Request for Class II Permissive Change

FCC ID: AJY2023FCS866R

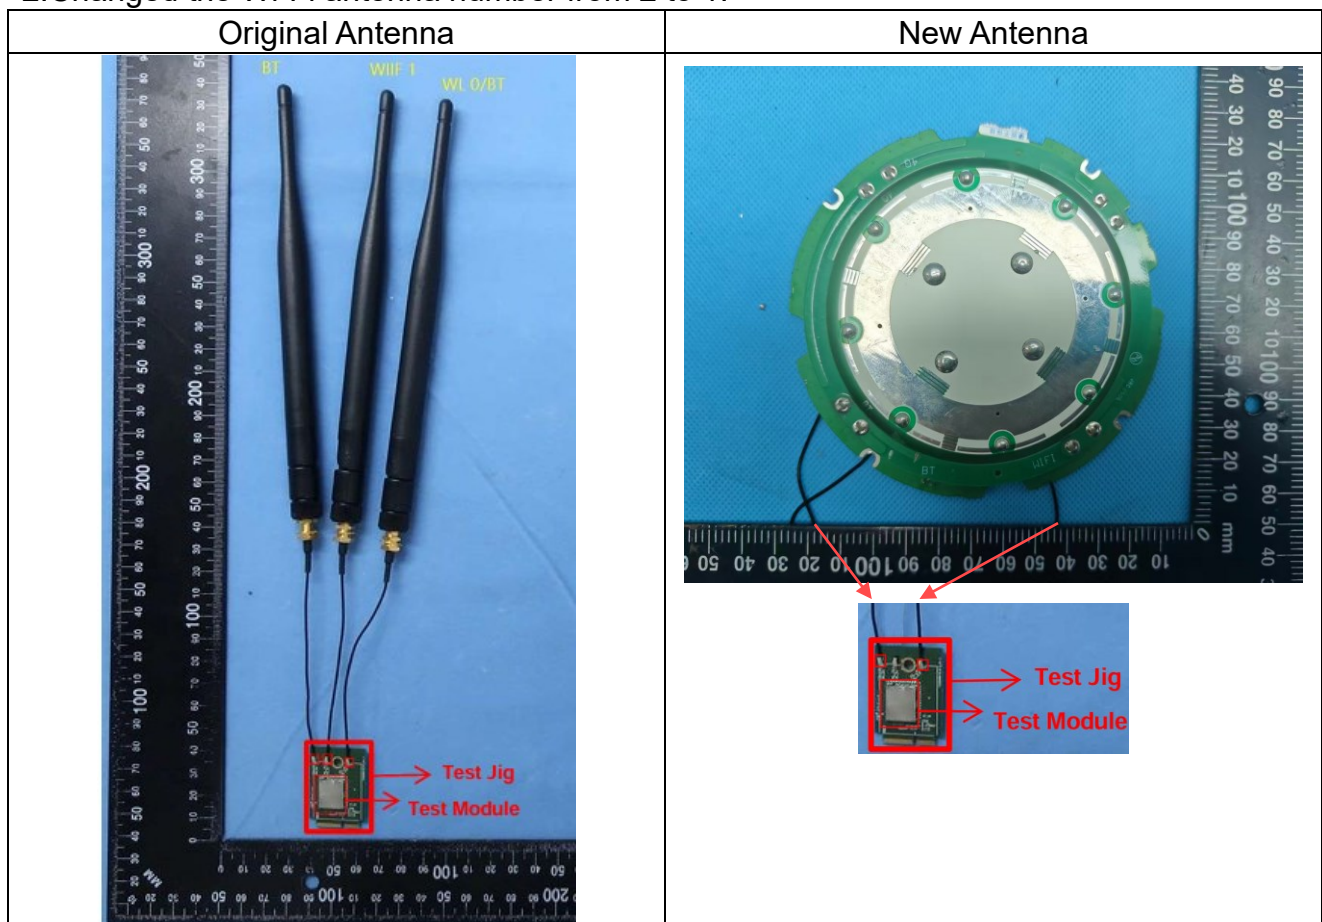
- 1.Replacing new Integral Antenna with different antenna gain (0.5dBi Max@2410 to 2480MHz, -1.8dBi Max@5150 to 5850MHz) from the original antenna (-0.1dBi Max@2400 to 2500MHz, 0.4dBi Max@5150 to 5850MHz).
- 2.Changed the Wi-Fi antenna number from 2 to 1.
